The following erratum presents a correction of ANSI/HI 9.6.4 Rotodynamic Pumps for Vibration Measurements and Allowable Values, approved on June 4, 2024. An erratum is issued to change and revise any editorial corrections or errors introduced during the publishing process of an existing published Hydraulic Institute standard/guideline.

Figure as
originally published

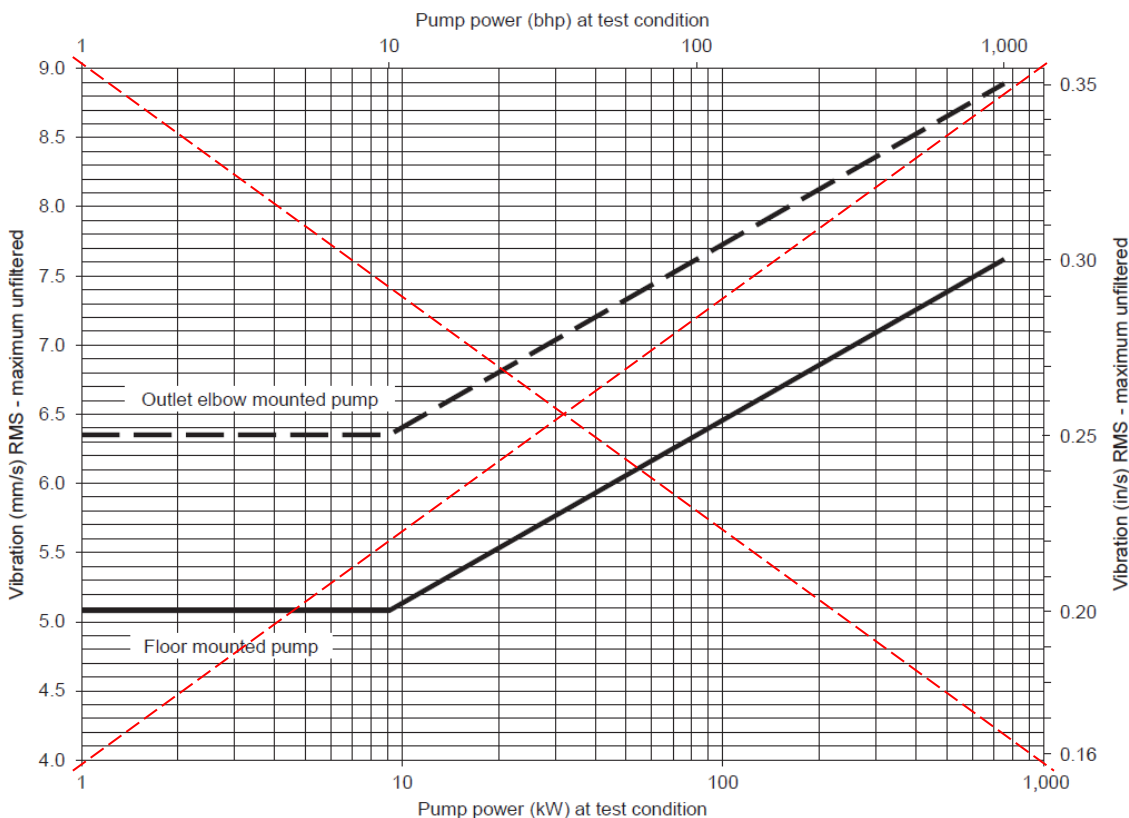
| <u>Page</u> | <u>Erratum</u> |
|-------------|---|
| 15 | Figure 9.6.4.3.2.4 – Updated the figure to correct the secondary x-axis denoting pump power (bhp) at test condition by shifting the values at 10 bhp and 100 bhp to the left and shifting the graph accordingly to correspond with values as originally shown in ANSI/HI 11.6-2017. |
